Planning, Zoning and Building Department

Project Name: Delray Medical Center
Project Location: 5352 Linton Blvd
Request: Class II Site Plan Modification
Board: Site Plan Review and Appearance Board
Meeting Date: May 10, 2017

ITEM: Delray Medical Center – Class II Site Plan Modification, Landscape Plan, and Architectural Elevations Associated with the previously approved Bed Towers and Parking Garage. (File 2017-137)

**DELRAY MEDICAL CENTER
BED TOWER EXPANSION
CLASS II SITE PLAN REVIEW
April 6, 2017**

PROJ. NO. 144446004	SHEET
DRAWN RMM	
CHECKED SES	C3.00

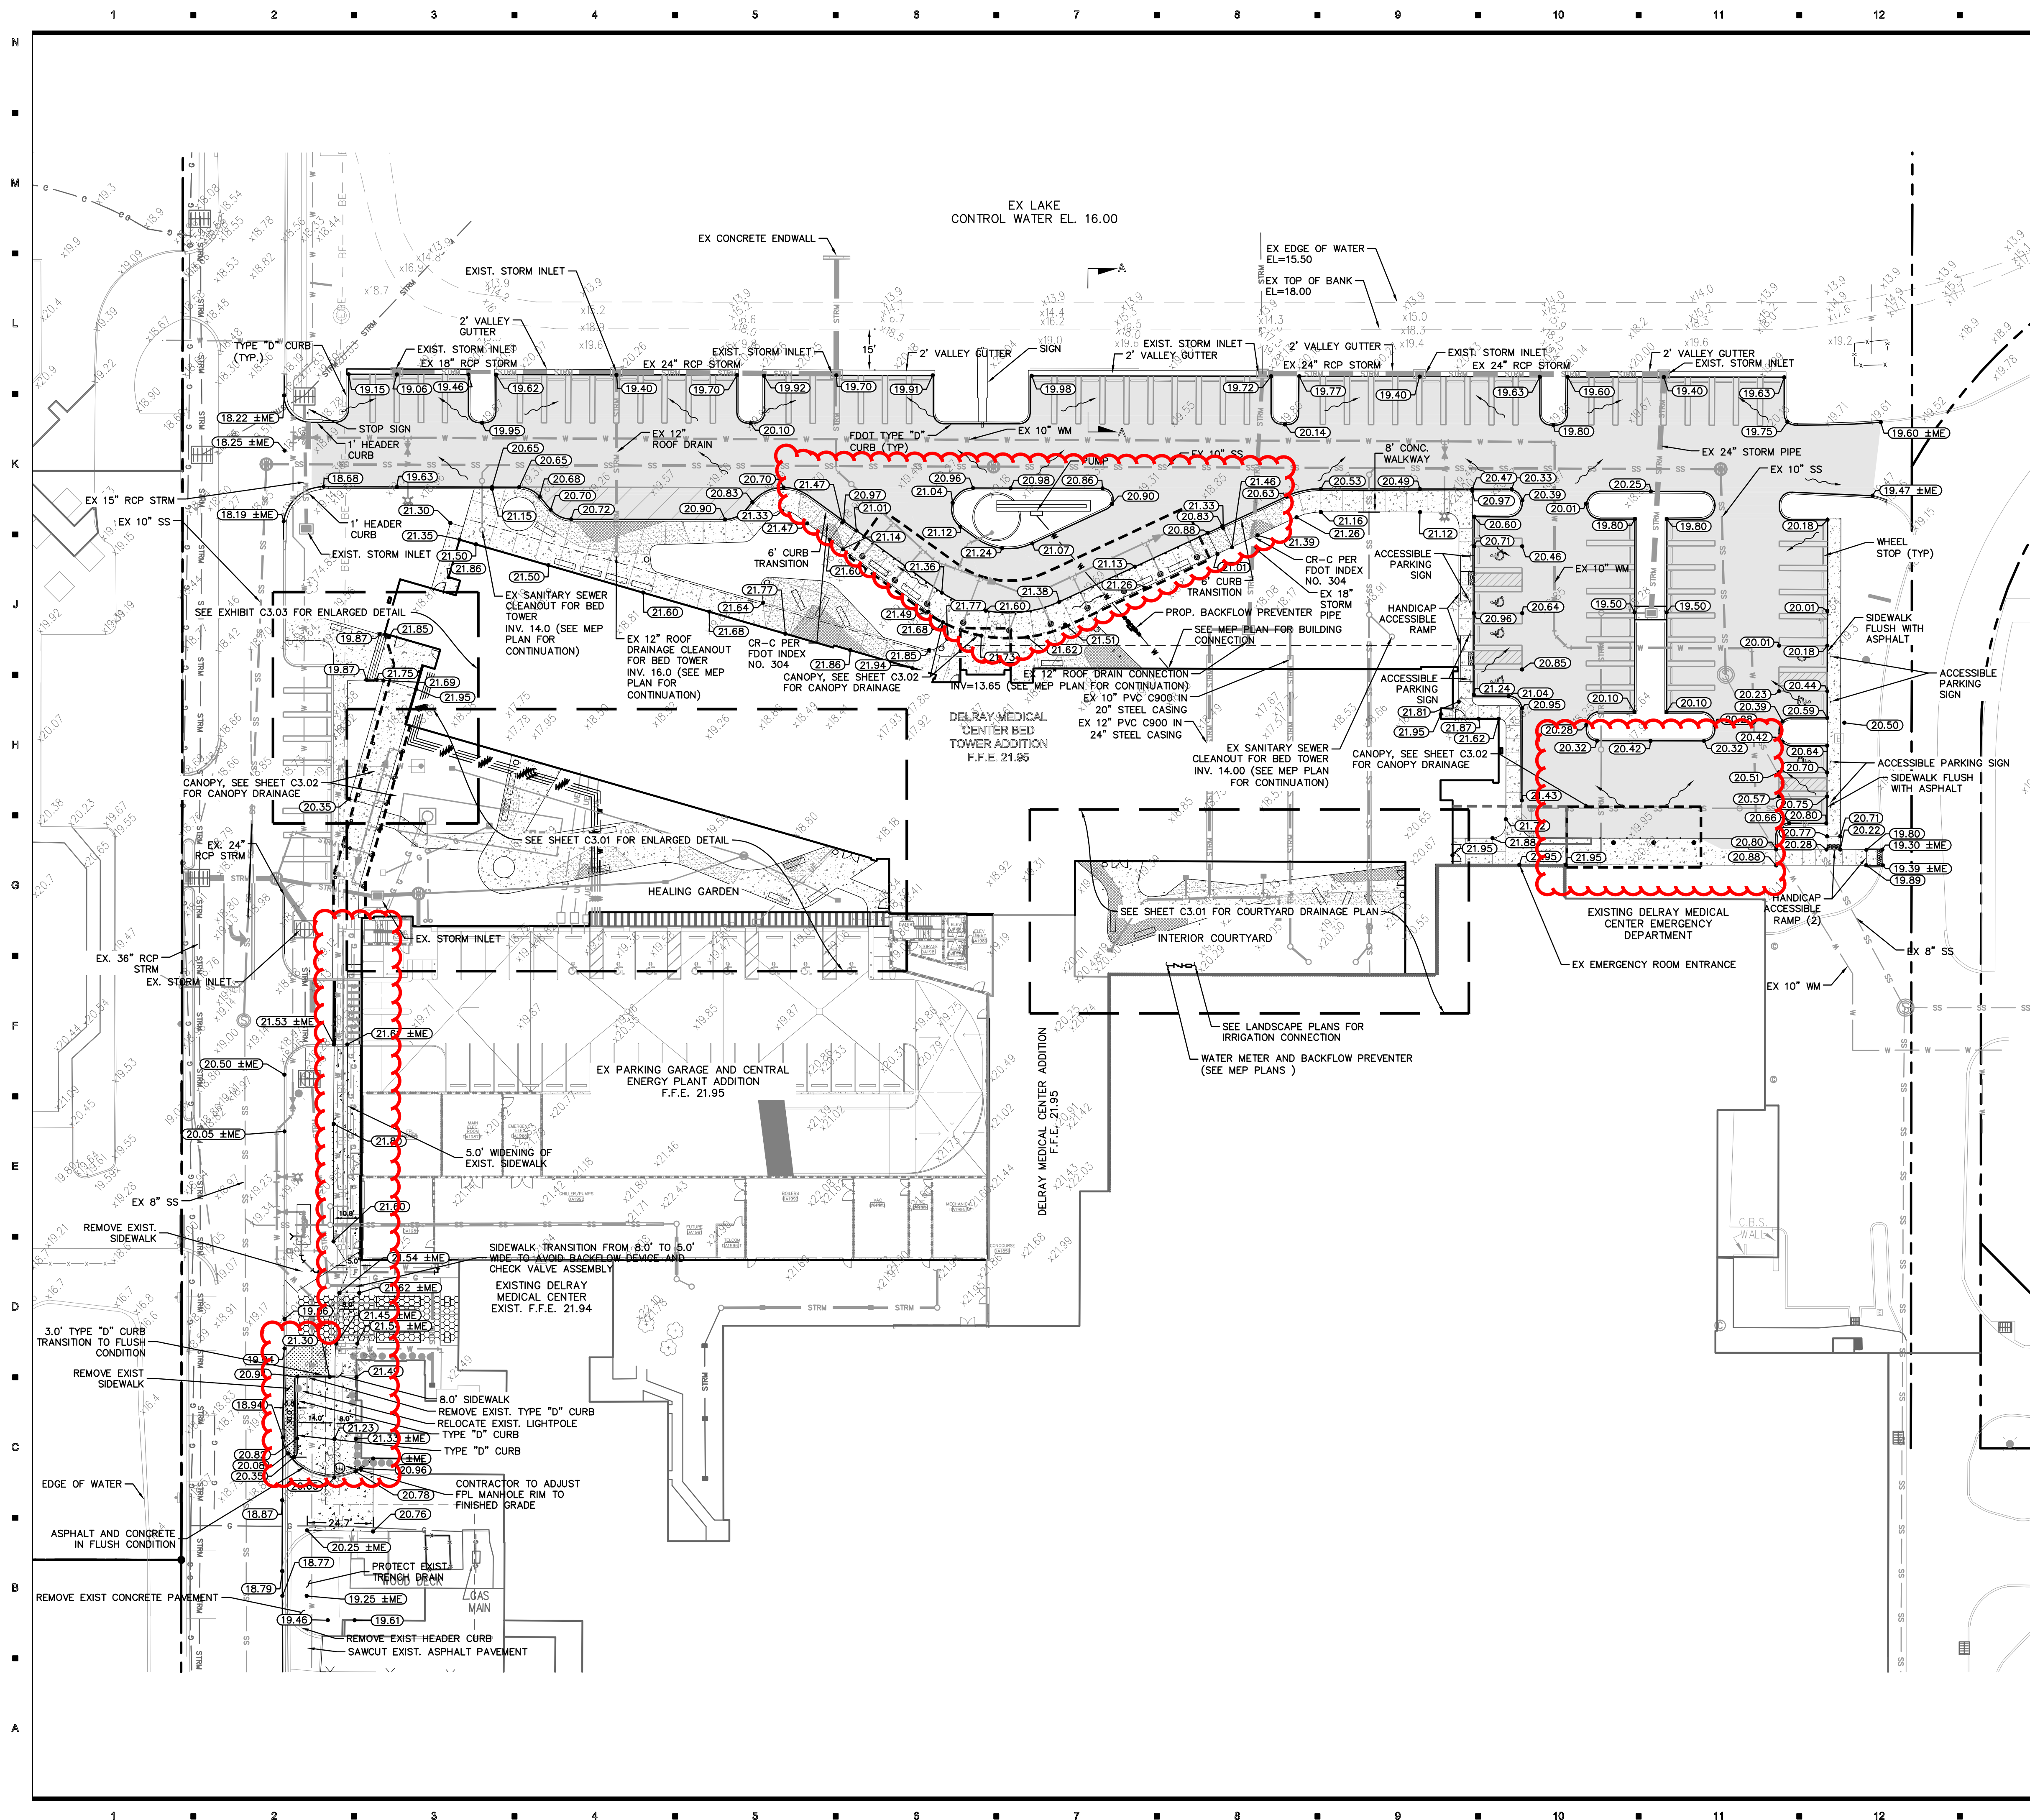
1. Amend plans to reflect asphalt pavement at the new Bed Tower drop-off drive. Plans previously called for decorative pavers. (*Engineering Plan C3.00, Hardscape Plan L3.00 and L3.01*)

2. Amend plans to reflect asphalt pavement at the Emergency Room drop-off drive. Plans previously called for concrete. (*Engineering Plan C3.00*)
3. Reduced the Main Drop-off canopy square footage area by 590 square feet, as provided during permit. (*Site Plan SP-1*)

4. Reduced the ER Drop-off canopy area by 1,749 square feet. Canopy has been eliminated over the ER drop-off drive isle.
(*Site Plan SP-1, Engineering Plan C3.00, Exterior Elevation A203, Floor Plan A120*)

5. Add an additional 5-foot of width to the existing 5-foot walk located on the west side of garage, as it extends south.
(*Site plan SP-1, Engineering Plan C3.00, Hardscape Plan L3.00 and L3.01*)

6. Add a new 8-foot sidewalk west of the Oxygen storage area, located south of the garage. Sidewalk to provide connection to the parking garage.
(*Site Plan SP-1, Engineering Plan C3.00, Hardscape Plan L3.00 and L3.01*)

7. Add a 14-foot wide loading zone west of the Oxygen storage area.
(*Site Plan SP-1, Engineering Plan C3.00, Hardscape Plan L3.00 and L3.01*)
8. Add sidewalk detail for proposed sidewalk showing a thickened edge for the condition that occurs where the decorative concrete walk meets the asphalt paved drop off area. (*Hardscape Plan L3.10*)

LANDSCAPE PLAN
PROJ. NO. SHEET
DRAWN
CHECKED
L1.00

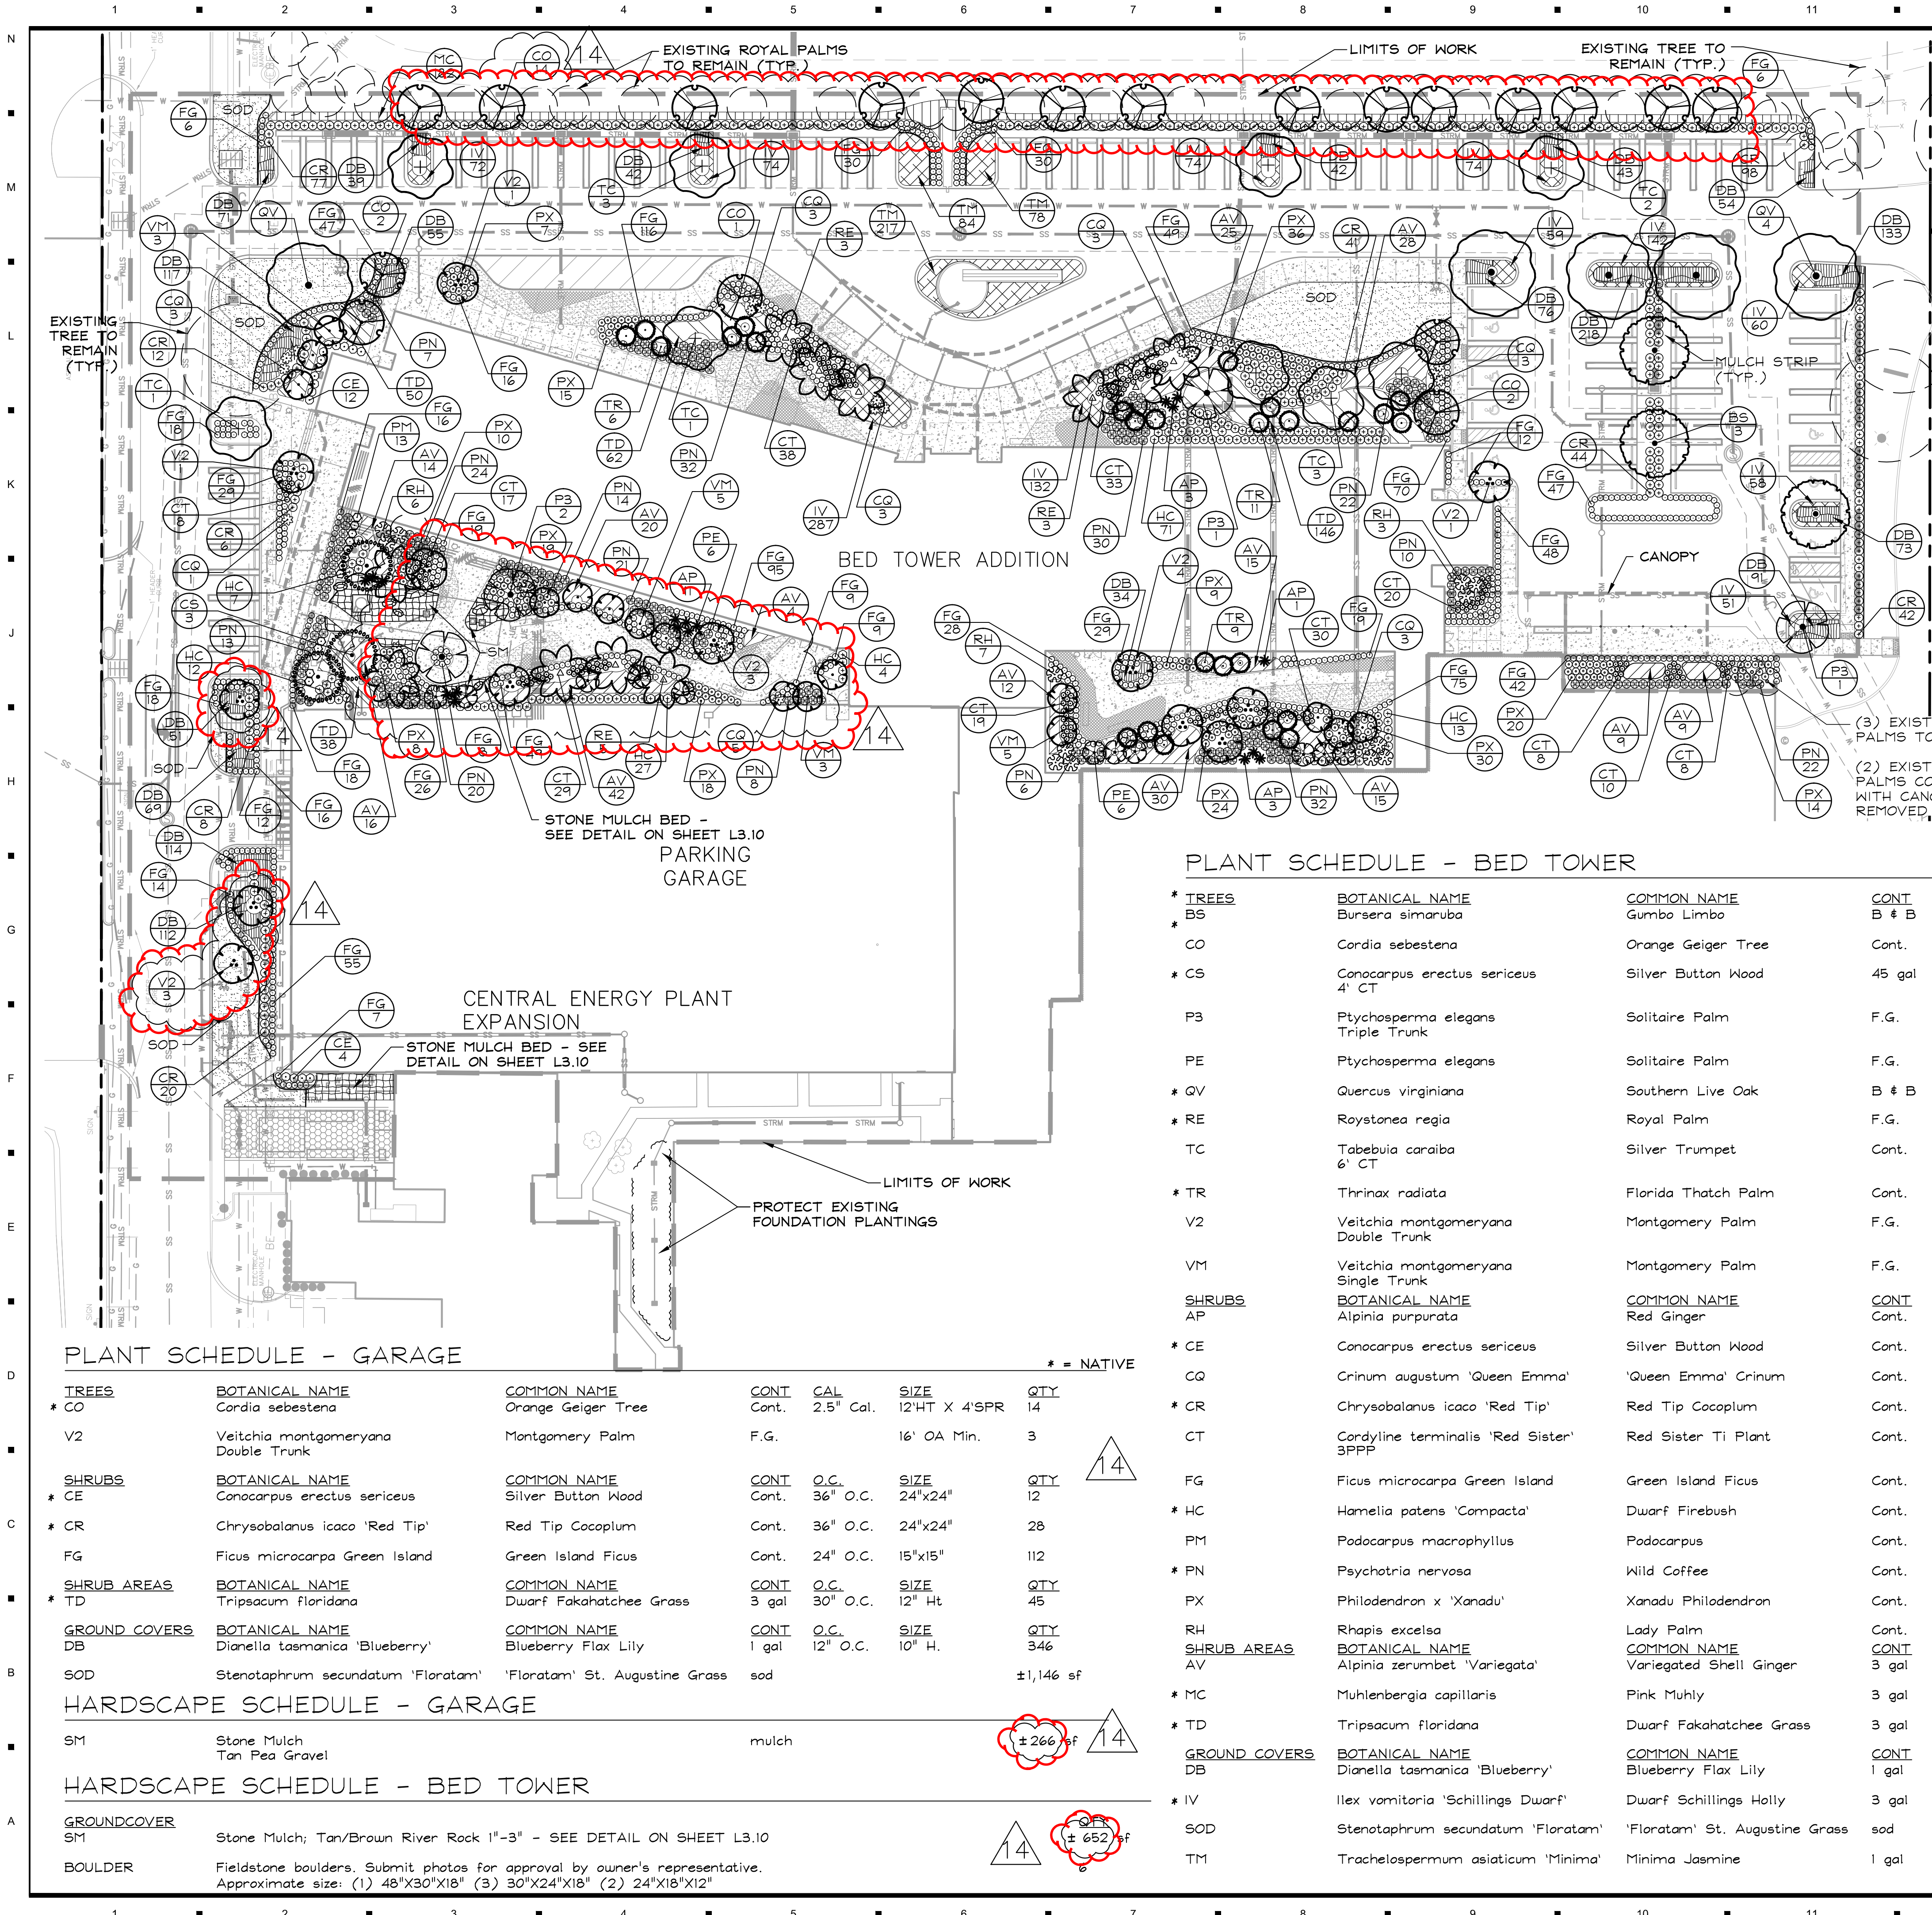
9. Landscape modifications include:
(*Landscape Plan L1.00*)

- The previously approved Live Oaks that were to be relocated along the south side of the lake did not survive the relocation. Per conversations with Peter Anuar the Live Oaks were replaced with the more appropriately sized Orange Geiger. This has been reflected on the updated Landscape Plan.
- Within the interior courtyard, single trunk Solitaire Palms have been replaced with double trunk Montgomery Palms provide additional clearance from the building, which then lead to minor changes in species and specifications.
- Royal Palms approved along west side of garage have been replaced with double trunk Montgomery Palms due to utility easement conflicts.
- Plant Schedules have been updated accordingly.
